*TOLEDO CITY
PLAN COMMISSION
REPORT*

October 13, 2016

| 4. SPR-38-16 | Major Site Plan Review for building addition at 1212 E. Alexis Road (rs) |

SITE PLAN

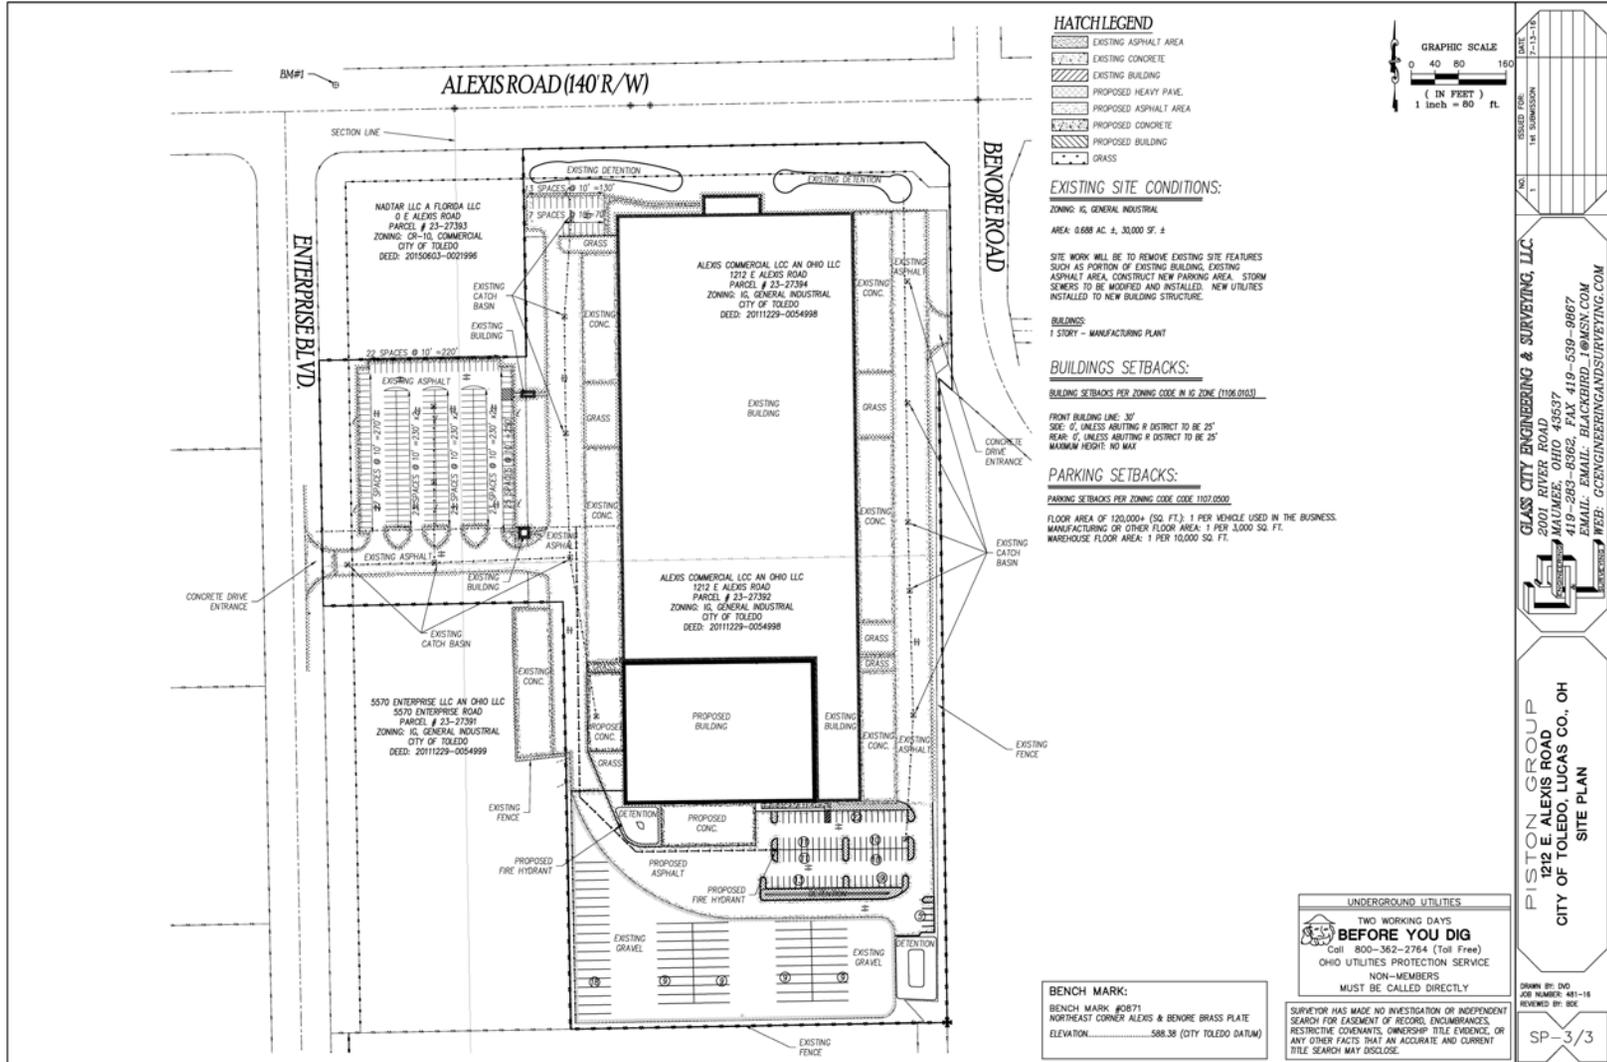
The site plan submitted depicts a total of 232 existing parking spaces and fifty-four (54) semi parking spaces on-site, with the addition of ninety-one (91) new parking spaces as part of the expansion for a total of 377 parking spaces. The site plan submitted did not depict any bicycle parking spaces or accessible parking spaces. If approved, a revised site plan depicting the bicycle parking and accessible parking shall be submitted in compliance with the Toledo Municipal Code (TMC§1107.0900 & TMC§1107.1700).

The Division of Transportation does not object to the approval of the submitted site plan, however, they have identified several issues which are listed as conditions of approval. The first condition is the site plan must include the dimensions of the parking stalls and drive aisles, specifically in the area of the proposed modifications. Second, the Division of Transportation requests the existing gravel area shall be surfaced with concrete, bituminous asphalt, or other dust free material other than gravel or loose fill. Third, all parking areas must be marked and striped in accordance with the requirements of the Toledo Municipal Code, and finally the parking on site must include accessible parking for physically disabled persons and meet the requirements of the Toledo Municipal Code. If approved, a revised site plan shall be submitted addressing the Division of Transportations conditions.

The site plan submitted depicts a thirty (30) foot front setback along Alexis Road, Benore Road and Enterprise Boulevard but no existing or proposed landscaping in the frontage greenbelts. Per TMC§1108.0202 *Frontage Greenbelts*, sites over five (5) acres are required to provide a thirty (30) foot frontage greenbelt along the right-of-ways. The frontage greenbelt shall include at least one tree for every 30 feet of lot frontage. Trees are not required to be evenly spaced and may be clustered. In order to bring the site closer into compliance, staff is recommending frontage greenbelts be installed along Benore Road and Enterprise Boulevard in conformance with TMC§1108.0202. If approved, a completed landscaping plan accurately depicting the frontage greenbelts shall be submitted.

38. The site plan must include the dimensions of the site including, parking stalls and drive aisles, specifically in the area of the proposed modifications.
39. The existing gravel area is shown to be utilized for parking; the gravel shall be surfaced with concrete, with bituminous asphalt, or other dust free material other than gravel or loose fill.
40. All parking areas must be marked and striped in accordance with the requirements of the Toledo Municipal Code.
41. ADA parking must be included on the site and meet the requirements of the Toledo Municipal Code.

42. An alternative parking plan shall be submitted to the Director to justify the parking in excess of 150 percent.
43. A revised site plan shall be submitted depicting the location and quantity of proposed bicycle and accessible parking spaces.

- a. A thirty-foot (30') greenbelt is required along the Benore Road and Enterprise Boulevard frontages, and shall one tree per every 30 feet of frontage; **unacceptable as depicted on site plan, shall be noted on revised landscaping plan.**
